To: Kristopher Byrd, Well Construction and Compliance Section Manager
From: Travis Kelly, Well Construction Program Coordinator
Subject: Review of Water Right Application LL-1872
Date: January 4, 2022

Application # LL- 1872

SUBJECT: Scenic Waterway Interference & General/Local Surface Water Evaluation for Deschutes Ground Water Study Area

TO: Water Rights Section Date 11/15/2021
 FROM: Groundwater Section M. Thoma
 Reviewer's Name
 SUBJECT: Application LL- 1872 Supersedes review of _____
 Date of Review(s)

Map 1: showing location of proposed POAs and nearby water level wells

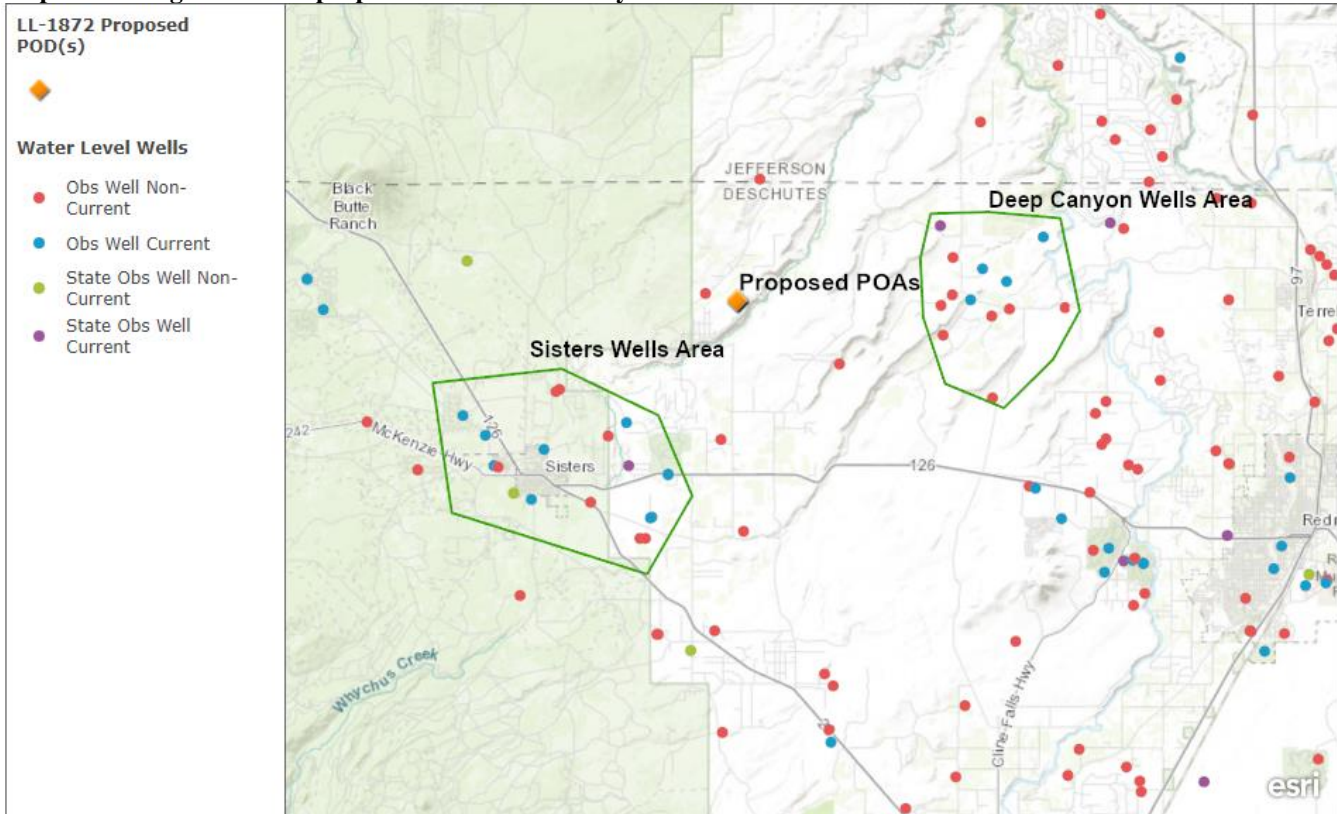
Several wells to the east of the proposed POAs (referred to as the "Deep Canyon Wells Area" in Map 1) are showing declining groundwater levels since the 1990s (see attached hydrographs). Studies by the USGS and OWRD have attributed these long-term declines to 1) long-term climate change, 2) groundwater pumping (see Map 2), and 3) canal lining causing reduced recharge. The nearest well exhibiting this trend is approximately five miles to the east of the proposed POAs, within a cluster of wells in that area showing the same trends. There are no applicable water level data between the proposed POAs and this cluster, or to the northeast between the proposed POAs and the regional discharge area near the confluence of

Hydrograph of wells in the vicinity of Sisters, OR which is near the regional recharge area; water levels are correlated with short-term climate variations; DESC 2000 and DESC 1416 are 0.8 and 2.9 miles from the proposed POAs, respectively.

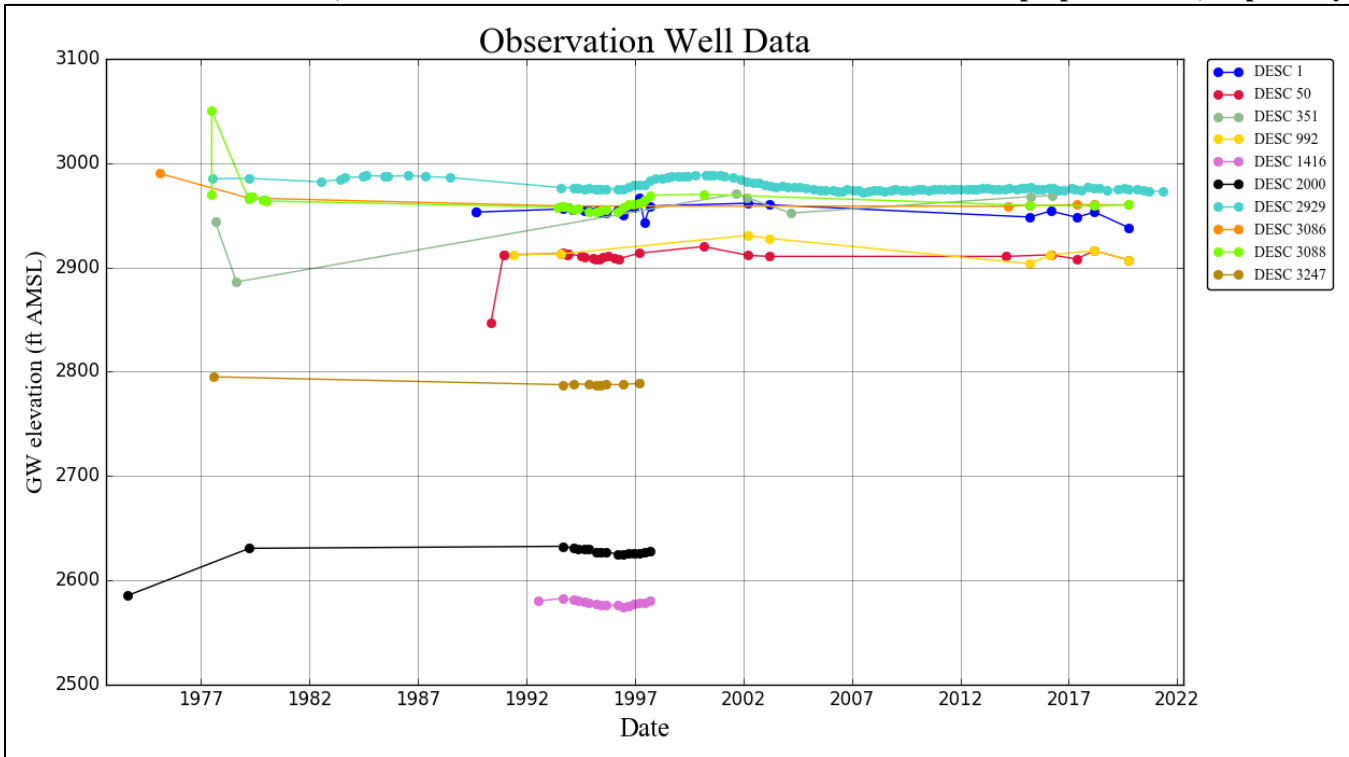
Whychus Creek and the Deschutes River. Wells to the southwest, near Sisters, show water level changes that more-closely match short-term climate variation (multi-year to decadal). There is little long-term water level data in the immediate vicinity of the proposed POAs so this review assumes water level trends are intermediate to those observed in the Sisters and Deep Canyon wells areas, representing a transition between those two zones.

The wells in the Deep Canyon area showing long-term water level declines are located generally down-gradient of the proposed POAs and thus farther from recharge zones for the region. Pumping under the proposed right would reduce groundwater flow toward the cluster and would contribute to the observed declines by capturing groundwater from along flowpaths that are providing lateral recharge to this area. (Lateral recharge being the main source of groundwater to the Deep Canyon area because of the disconnection between groundwater and surface water locally, and the large distance from the regional Cascade recharge zone.) Notwithstanding that there is a presumed likelihood of the proposed use to have a negative impact on groundwater levels (and thus senior groundwater rights) in the region, there is insufficient water level data near the proposed POAs to definitively conclude that the wells are not tracking short-term climate variation (as in the Sisters Area) and that recharge would be sufficient, during the period of use of this Limited License, to buffer the impacts of pumping under the proposed use as to not cause significant impact to the wells, and existing senior user, in the Dry Canyon area. Thus, it cannot be determined how the proposed use will affect the capacity of the resources and permit conditions listed in Section B(d) are recommended.

Prior to use under this Limited License, each POA shall be equipped with a method for measuring static water level and a reference water level must be provided to the Department. This can include an airline, measuring tube, or any other construction or equipment that allows access to report static water level measurements. The chosen water level measuring method shall be maintained in proper working order as to allow static water level measurements for the duration of the Limited License.
